# PREVOST

## WARRANTY BULLETIN

**WB18-06**

DATE :	April 2018	SECTION :	23 ACCESSORIES
EXPIRATION:	April 2020		
SUBJECT :	<b>RIGHT CONSOLE RAMP REPLACEMENT</b>

Figure 1

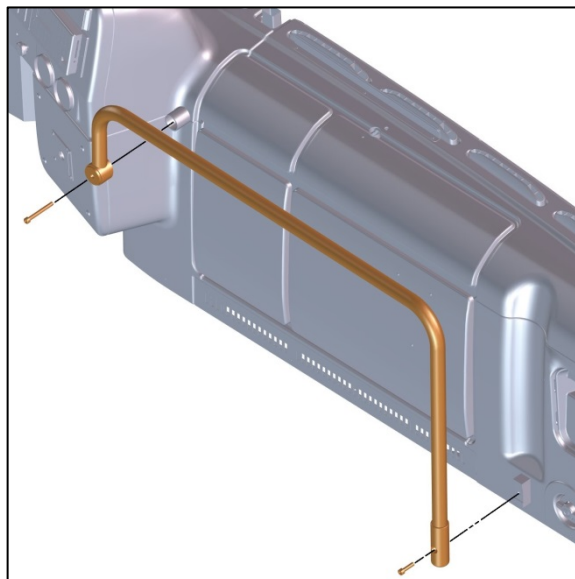
1. Locate the right console ramp (Figure 1).
2. Remove the existing right console ramp p/n 392494 (two socket head screws) (Figure 1).

Figure 2

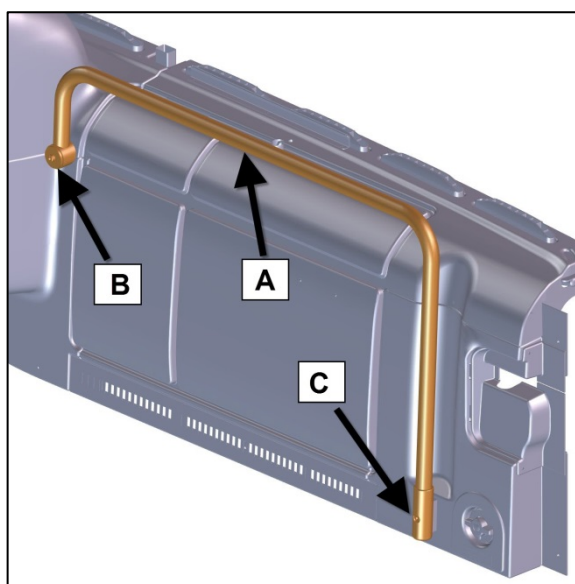
3. Position the new ramp p/n 3200962 on the right console (item A, Figure 2).
4. Install the new socket head screw p/n 5001604 to fix the left side of the ramp (item B, Figure 2).
5. Install the new socket head screw p/n 5001598 to fix the right side of the ramp (item C, Figure 2).
6. Bulletin is complete.
